Product Change Notification

Change Notification #: **104205 - 00**
Change Title: **Optical Networking, LXT16713A and LXT16723, PCN 104205-00, FYI**
Date of Publication: **July 1, 2004**

Diagram 1 – 4x4mm QFN package with heat sink dimension as a 2.60mm ±0.100mm sq exposed pad with tie bars (incorrect information for LXT16713A and LXT16723)

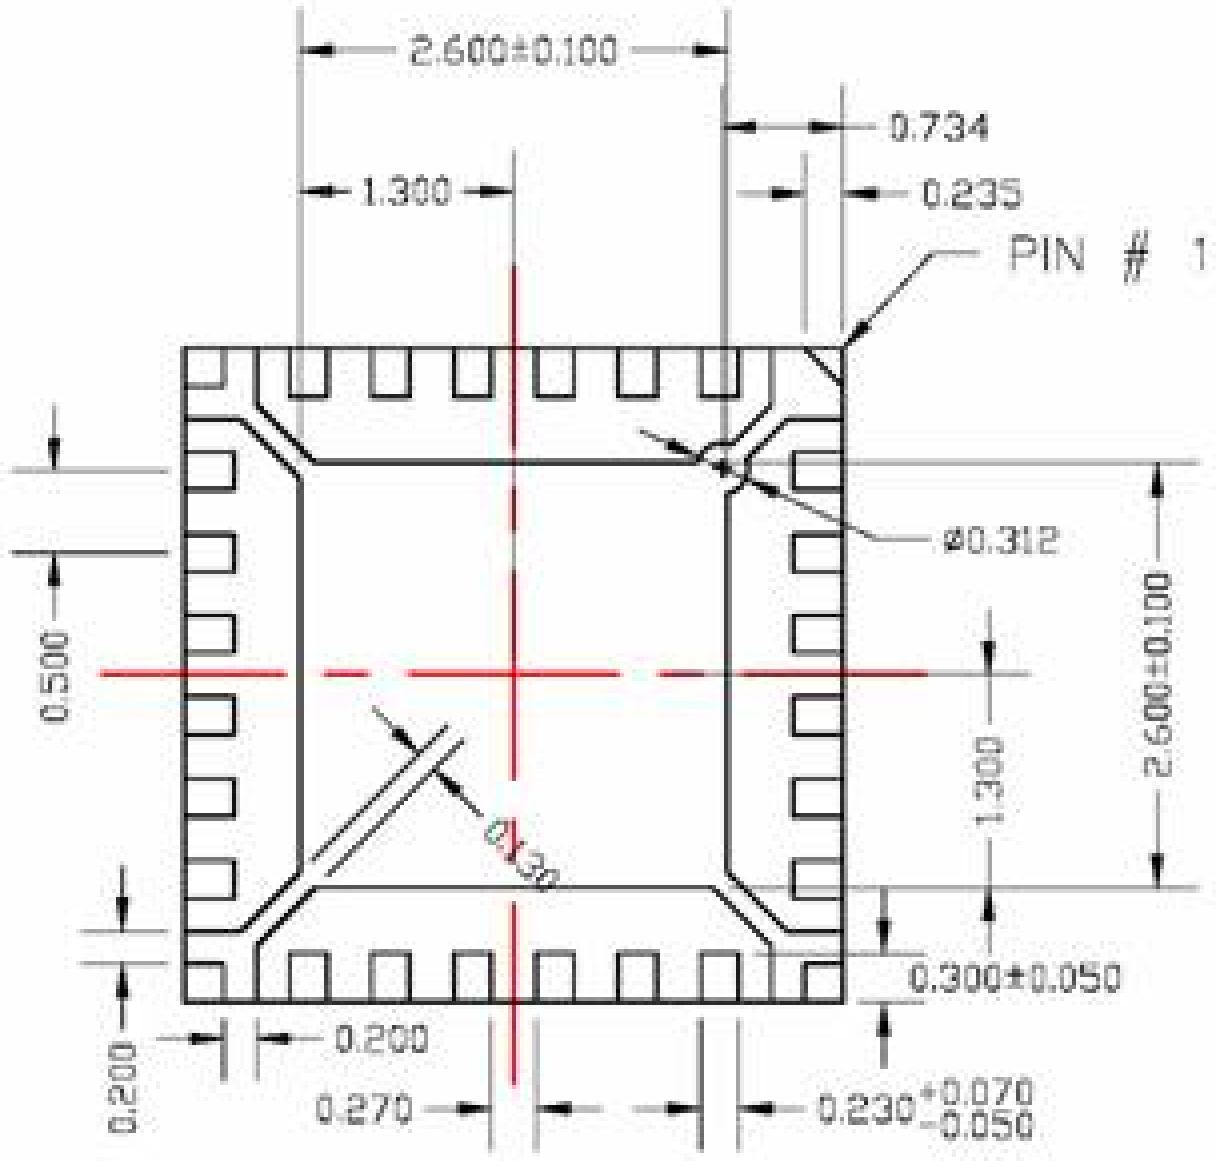
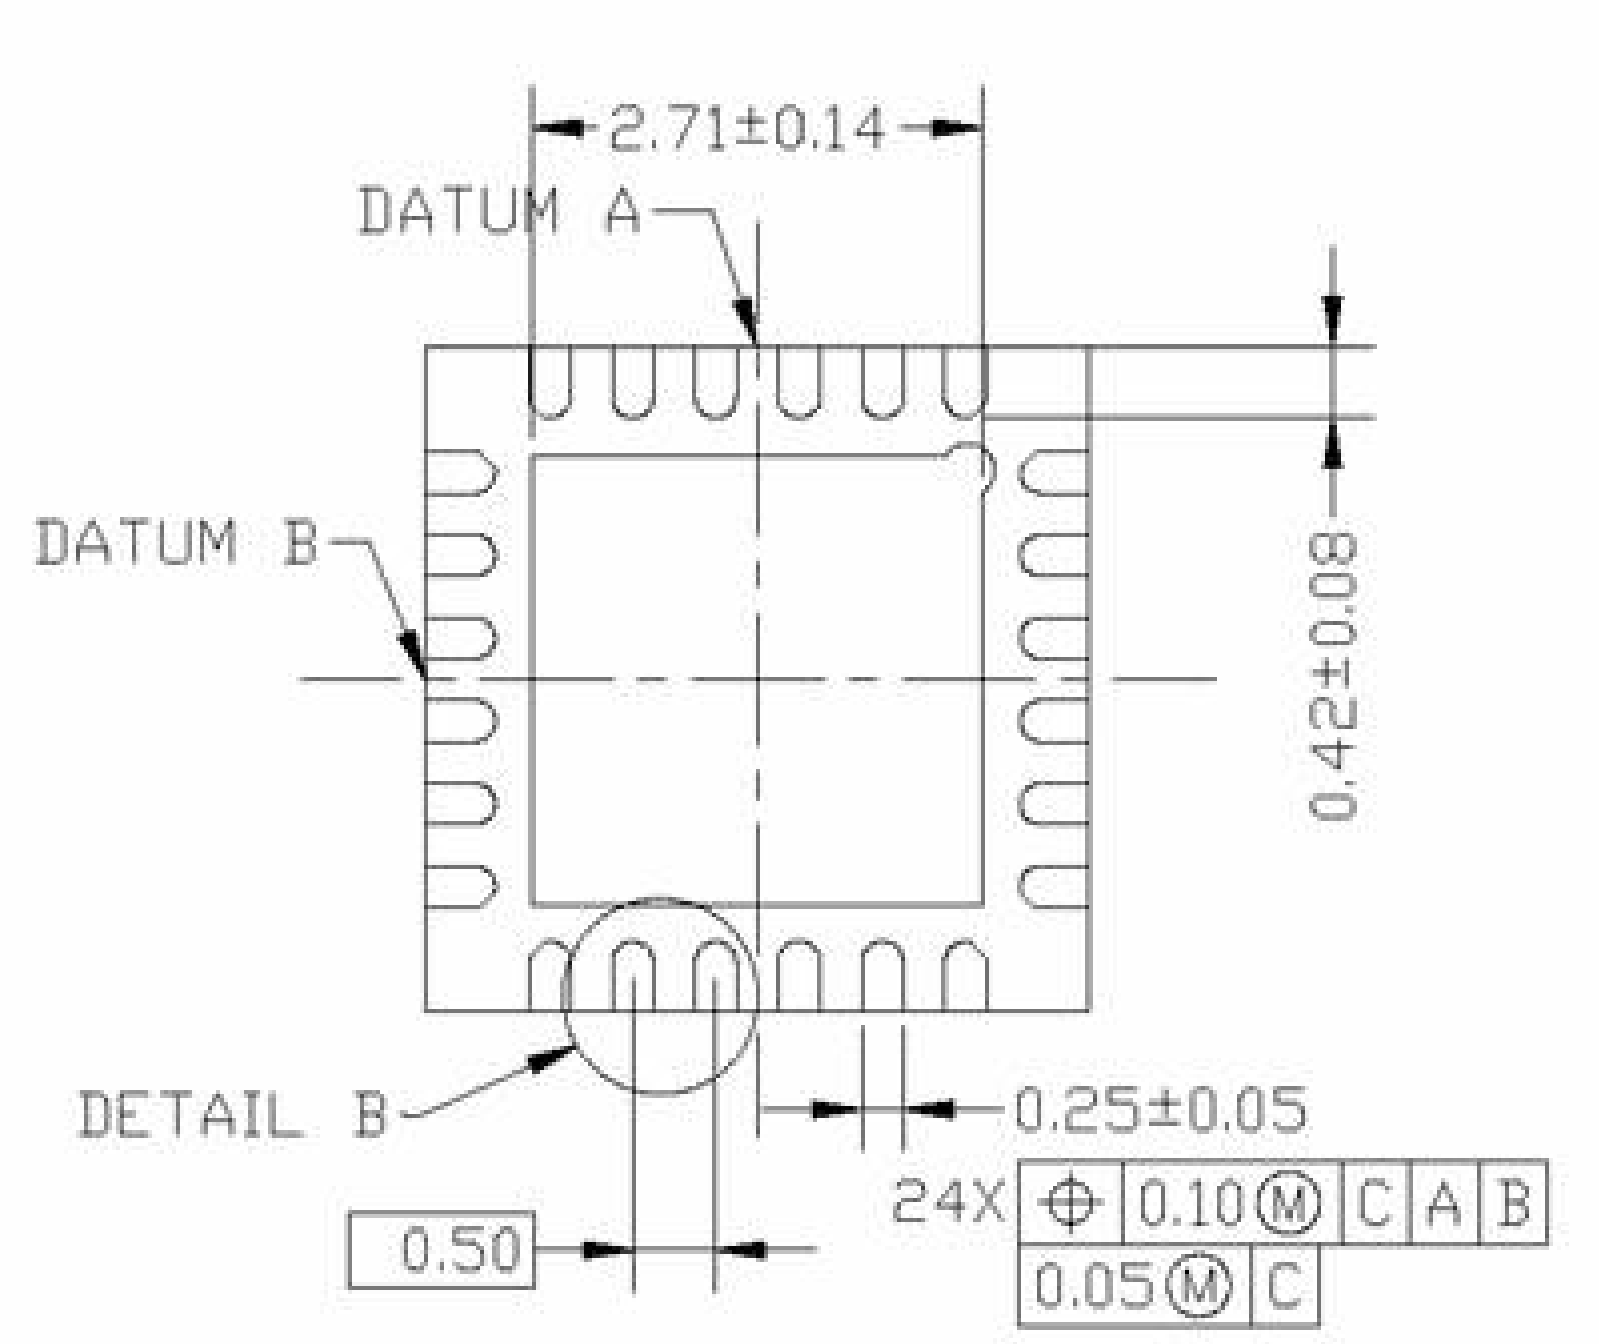
The package drawing in the datasheet for the Intel LXT16713A Rev. 006 and LXT16723 Rev. 002 4x4mm QFN package describes the heat sink dimensions as a 2.60mm ± .100mm sq exposed pad with tie bars. The correct information should have been 2.71mm ± 0.140mm sq. exposed tie bars, see diagrams below.

Diagram 2 – 4x4mm QFN package with heat sink dimension as a 2.71mm ± 0.140mm sq exposed pad without tie bars (correct information for the Intel LXT16713A and LXT16723)

Intel recommends that customers review their PCB traces below, and or around any of the effected components to avoid potential short circuit.
